Customer : CU-DAR001 Dart Helicopters Services	Drawing Name : HELI UTILITY BASKET LH/RH 350/355
Job Number : 48298	
Estimate Number : 10208	
P.O. Number :	Part Number : D350607043
This Issue : 29/05/2009 S.O. No. :	Drawing Number : D350-607 REV F P7-9
Prsht Rev. : NC	Project Number : N/A
First Issue : / / Type : LARGE FAB ASSY	Drawing Revision : F
Previous Run : 47941	Material :
Written By :	Due Date : 08/06/2009 Qty: 1 Um: Each
Checked & Approved By : <u>JUD 09.05.29</u>	
Comment : Est Rev:E as Per DSI9318 06-01-24 JLM Est Rev:F ECN1068 07-12-21 DD verified by:

DESIGN <i>CP</i>	DRAWN BY <i>CP</i>	DART AEROSPACE LTD HAWKESBURY, ONTARIO, CANADA	
CHECKED <i>[Signature]</i>	APPROVED <i>[Signature]</i>	DRAWING NO. DSI 9318	REV. A SHEET 1 OF 1
DATE 06.01.06		TITLE WASHER ADDITION	SCALE NTS
A	06.01.06	NEW ISSUE

DART SERVICE INSTRUCTION

TO AMEND INSTALLATION INSTRUCTIONS D350-607 REV. F

Figure 5- Basket Replacement Parts
(D350-607-043 Heli-Utility-Basket™)

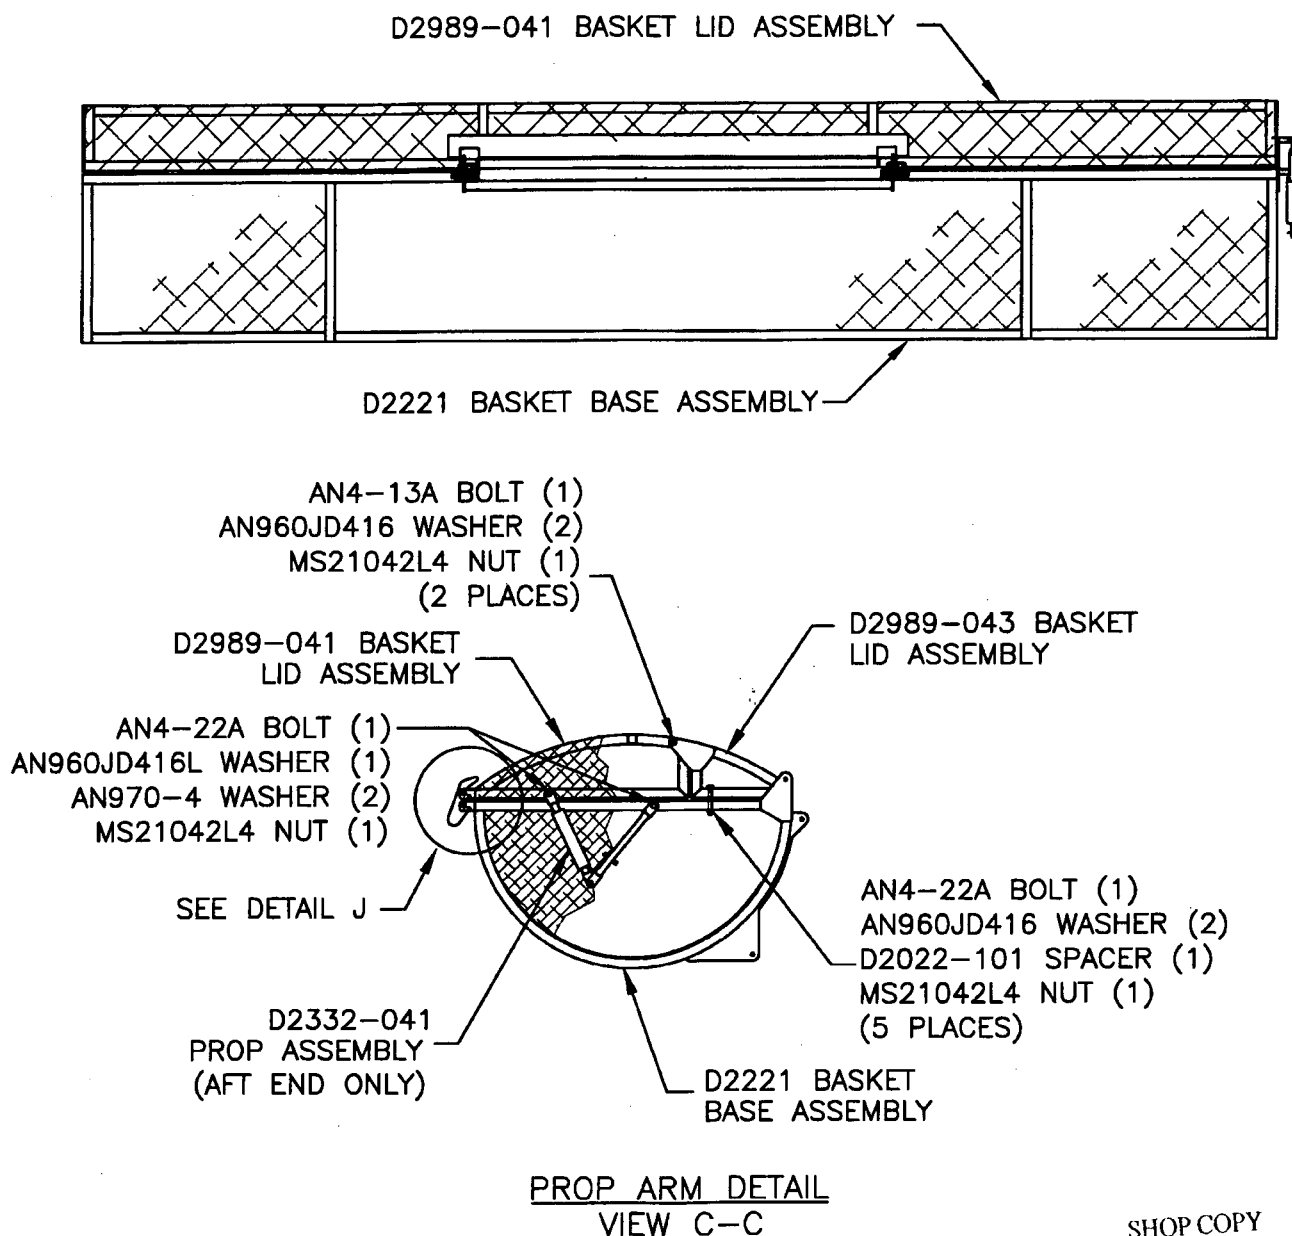
The corrected bolt stackup from Figure 5 of installation instructions D350-607 Rev. F is given below:

AN4-13A BOLT (1)
AN960JD416 WASHER (1)
HINGE PLATE (REF)
NAS1515H4 WASHER (1)
BASKET FRAME (REF)
AN960JD416 WASHER (1)
MS21042L4 NUT (1)
(2 PLACES)

BASKET FRAME (REF) HINGE PLATE (REF)

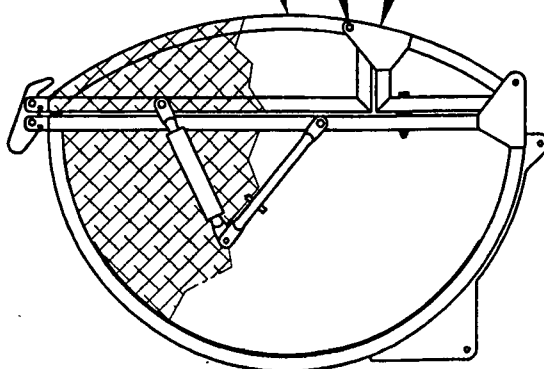
To reduce the possibility of damaging the finish, a **NAS1515H4** washer (2 places) has been added between the hinge plate and basket frame on the **D350-607-043/-047 Heli-Utility-Basket**.
